ADDENDUM #4

Rye City School District

Issued: 2021-02-17

PROJECT No: 9200
DRAWING BY: Author
CHK BY: Checker
DWG No:
A2-320

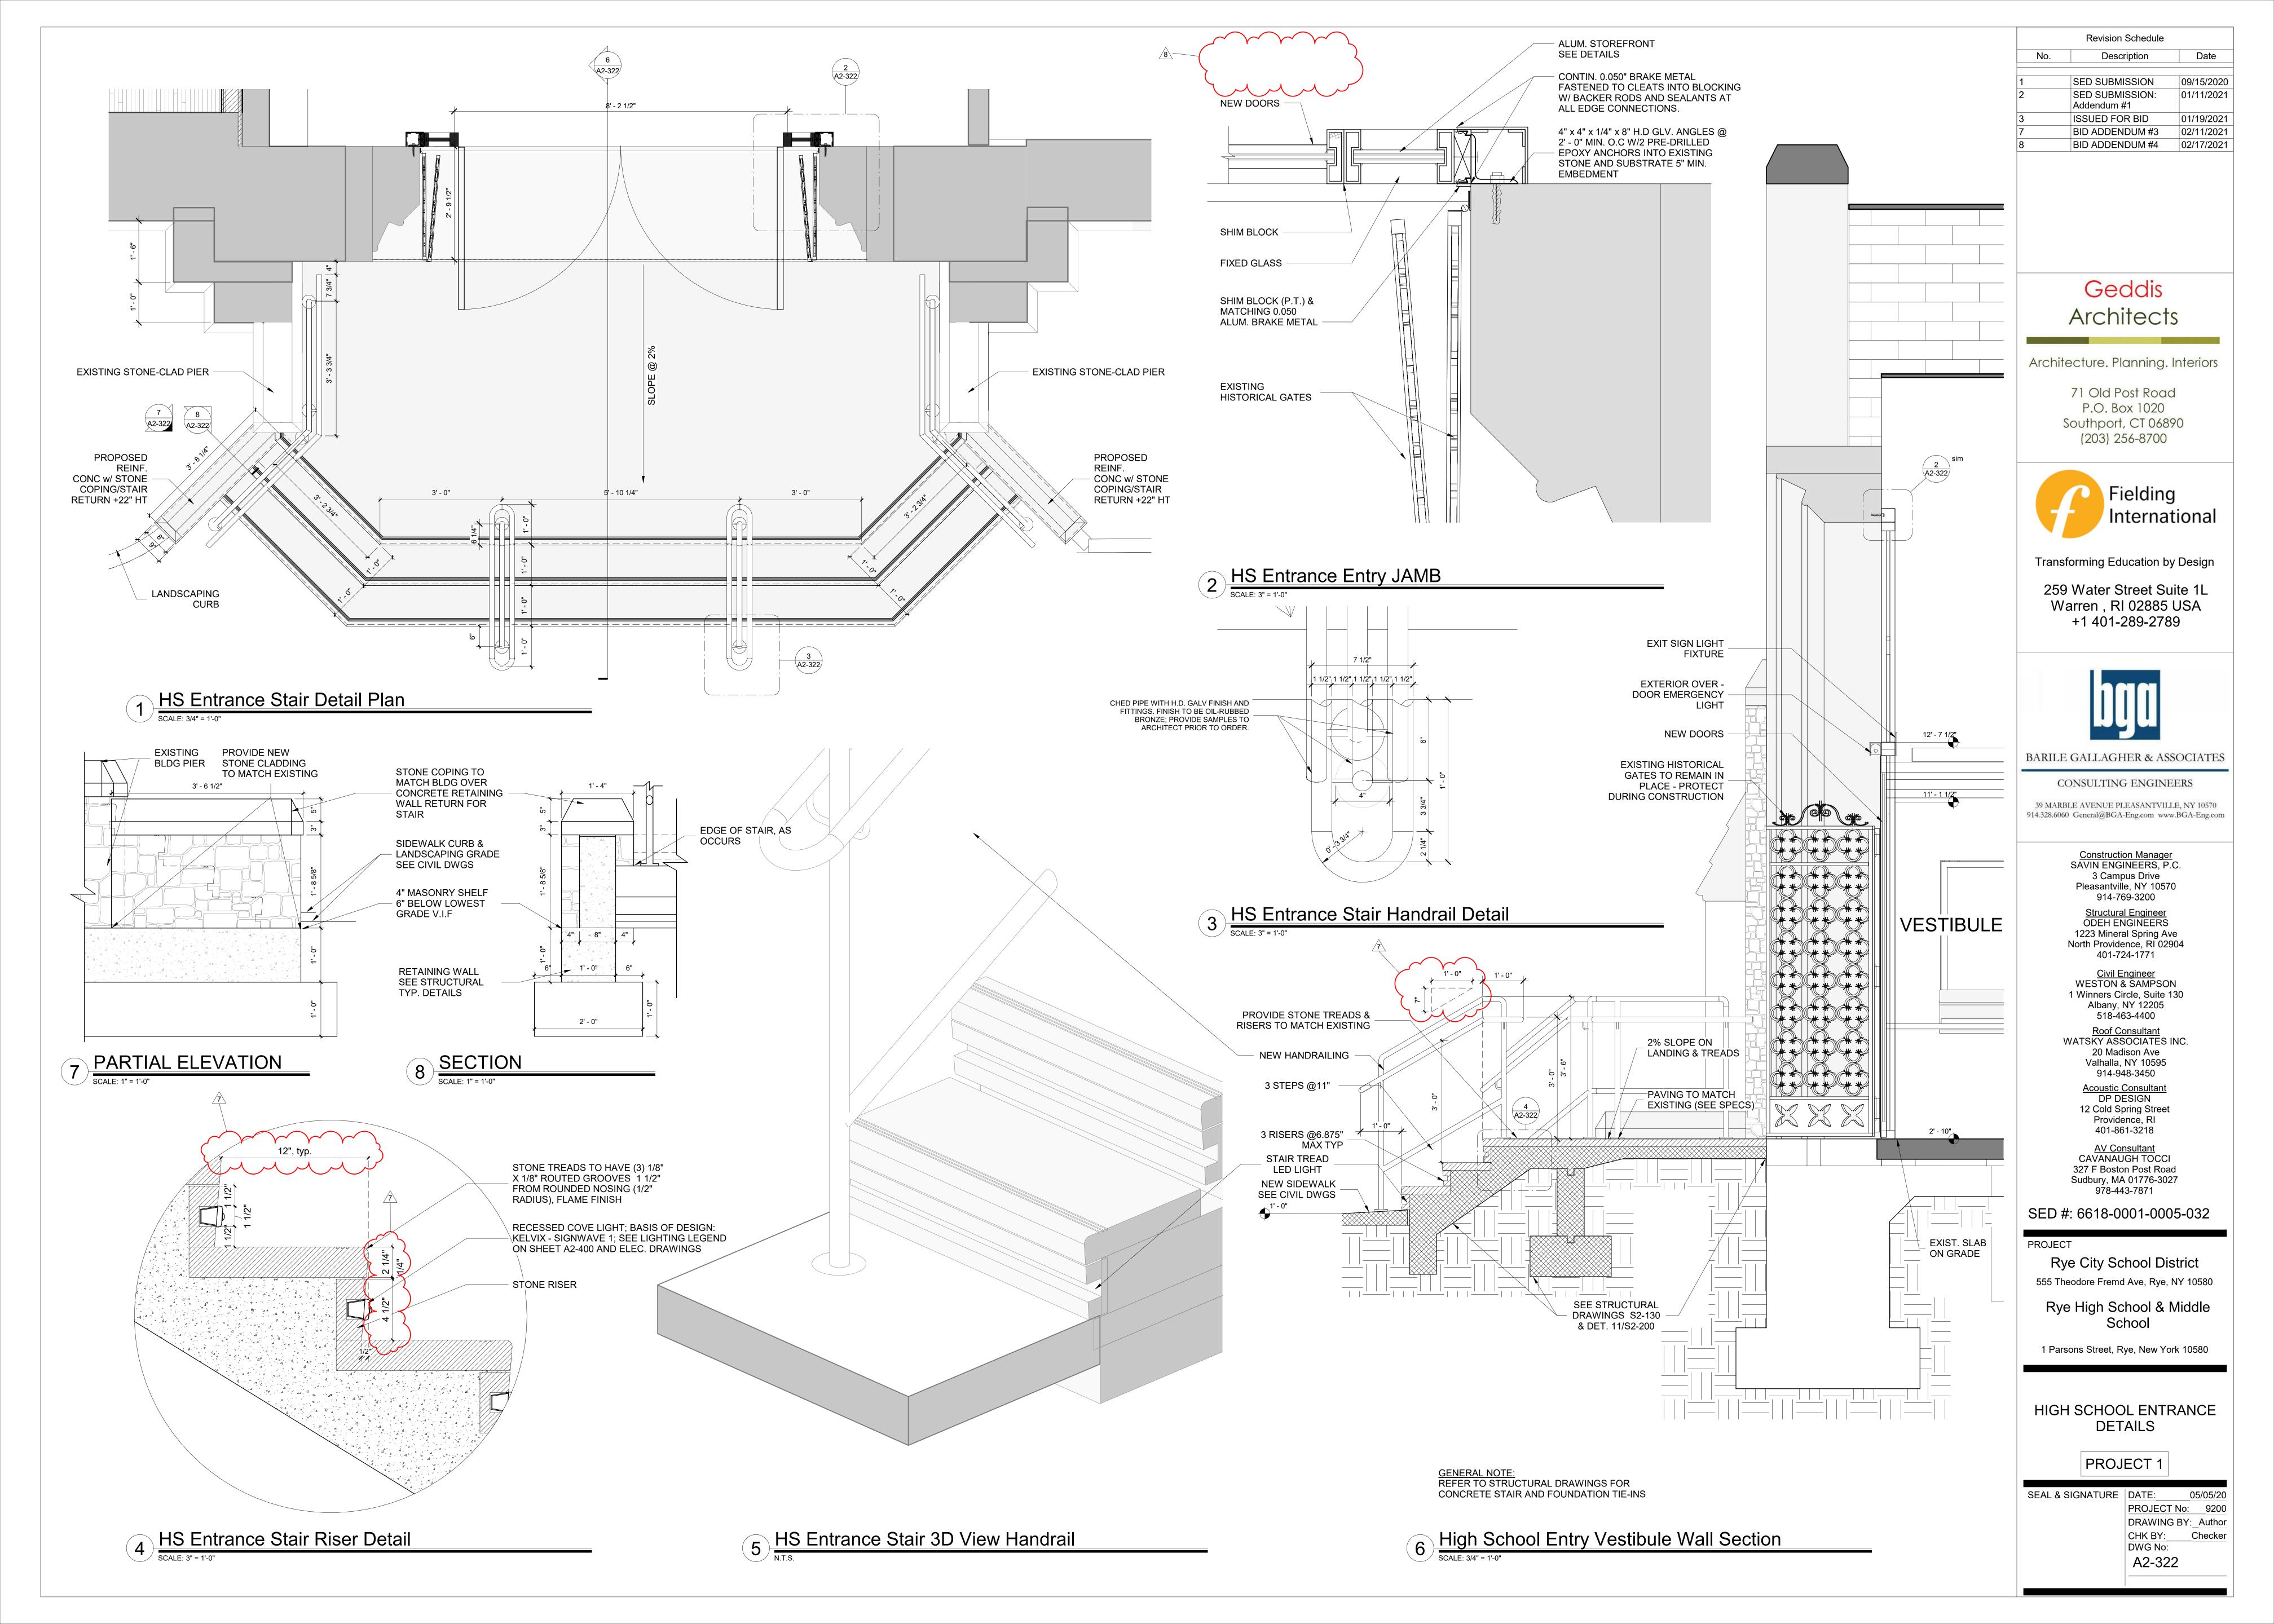
- 1. A2-320:
 - a. Detail #4 updated to show fully-finished opening ready for owner's casework contractor to install cave space.
- 2. A2-322:
 - a. Detail 2: Note referencing ballistic capture removed. Door and glazing at this location to be shooter attack system as originally specified.
- 3. A2-601:
 - a. Door E1-28 frame type updated.
 - b. Door schedule updated to show galvanized steel framing for 45min rated systems.
 - c. Door schedule updated to show hollow metal doors and frames.
- 4. A2-602:
 - a. Door types D-4 updated.

DRAWING BY:_Author CHK BY: Checker A2-420A

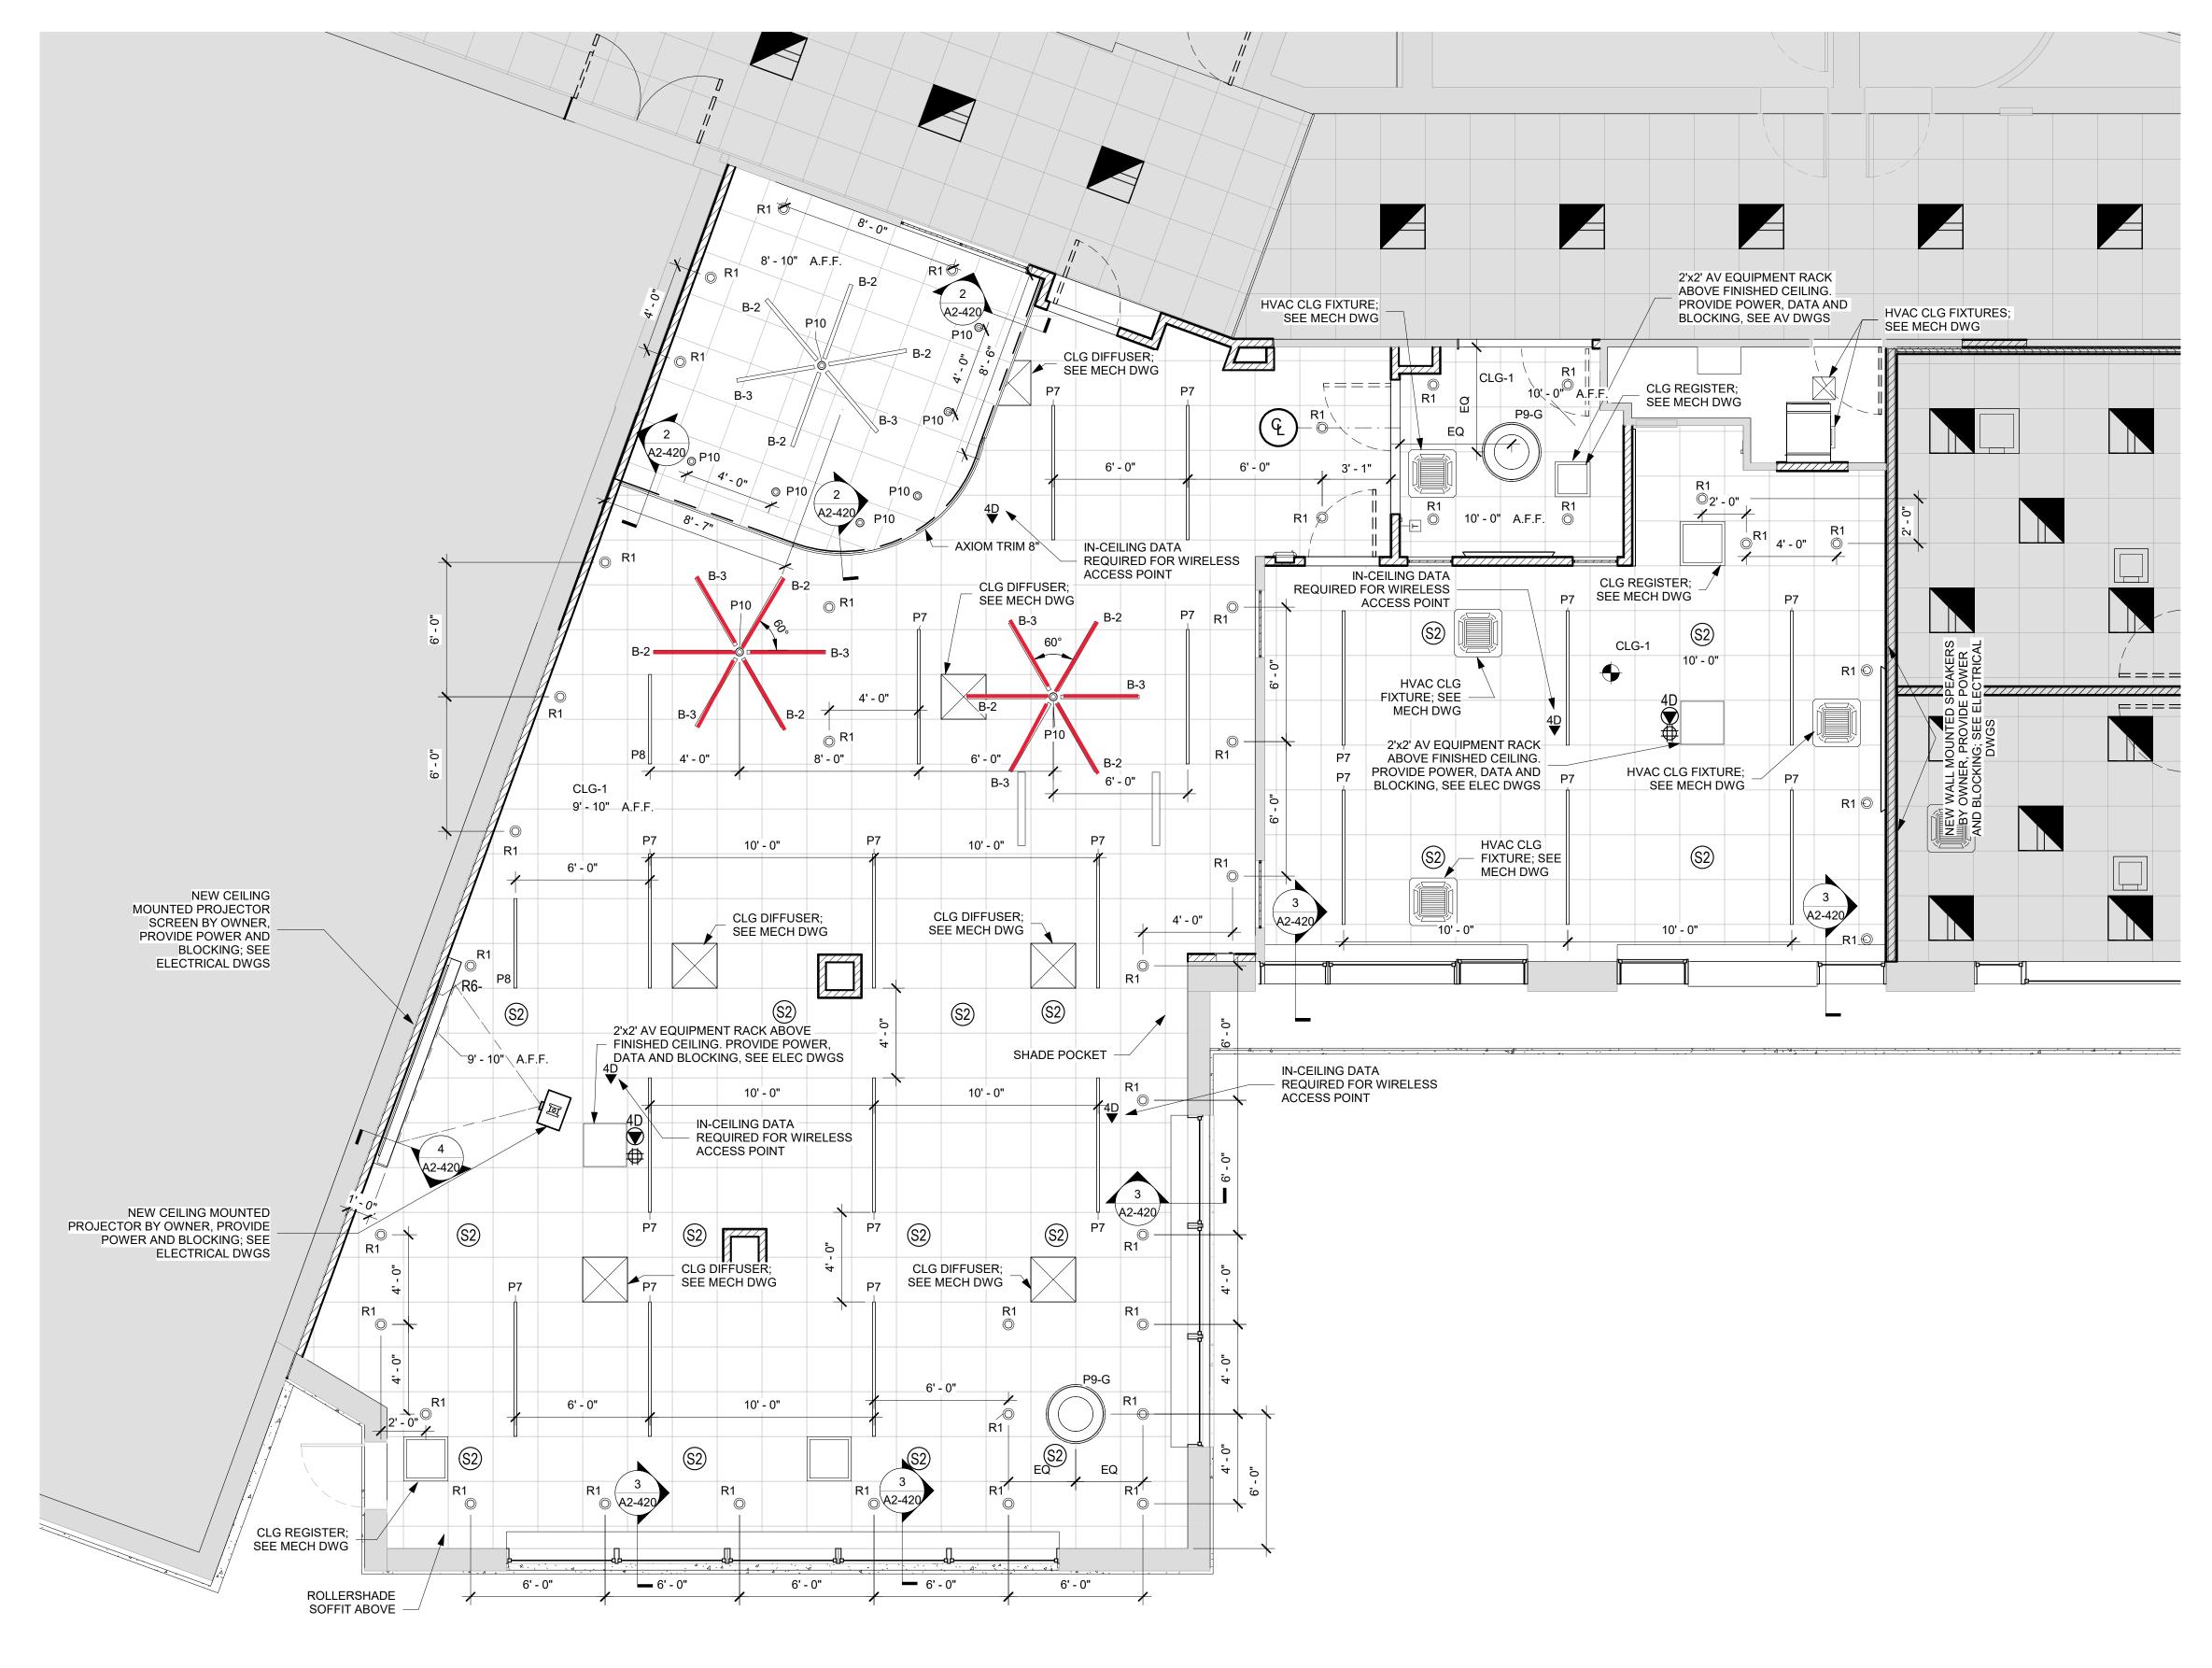
- 24. **Question:** Alternate C2 ceiling baffles in the library are not clearly shown. Please advise. **Response:** Alternate 2C in Osborn and Midland is shown on Drawing A2-420A in both drawing sets. See attached markup of these drawings showing the baffles in red.
